TCE COMMENTS:

2B	Reviewed. Comments enclosed. Incorporate the comments and re-submit for review.

TITLE - GATE				NIHVA TECHNOLOGIES PVT.LTD.PUNE
DWG NO - NTPL268-PM			QTY - 1	Website - www.nihva.com
	NAME	SIGNATURE	DATE	PROJECT NO - NTPL268-PM- AD
DRAWN	V.B.		02-05-2025	PRODUCT -SLIDING GATE
CHK'D	S.W.		02-05-2025	SITE LOCATION -
APPV'D	V.T.		02-05-2025	
if any queries contact - supportautomation@nihva.com				REVISION -00
ALL DIMENSION ARE IN mm			A3	SCALE - SHEET 1 OF 1

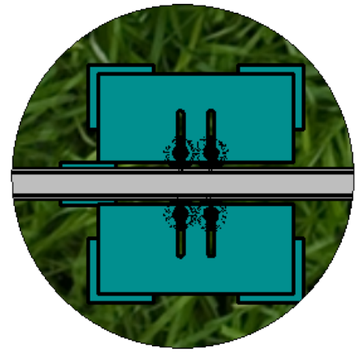
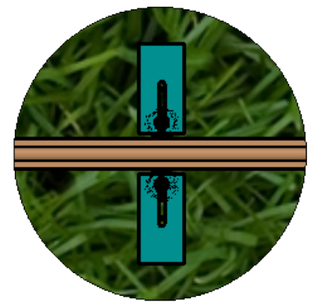
1. Please refer to the latest master layout for the exact site dimensions and space availability.

2. Barbed wire fencing above the sliding gate is under finalization with the Air India team. TCE will confirm shortly.

3. Please specify whether the elevation view is from the inside or outside. It is currently unclear.

4. As the door sizes are as per the requirement, kindly consider the weight and design the sections accordingly. Also, the wheel should be a double wheel, as shown in the architectural layout. Locking arrangement details are missing from the GA drawing.
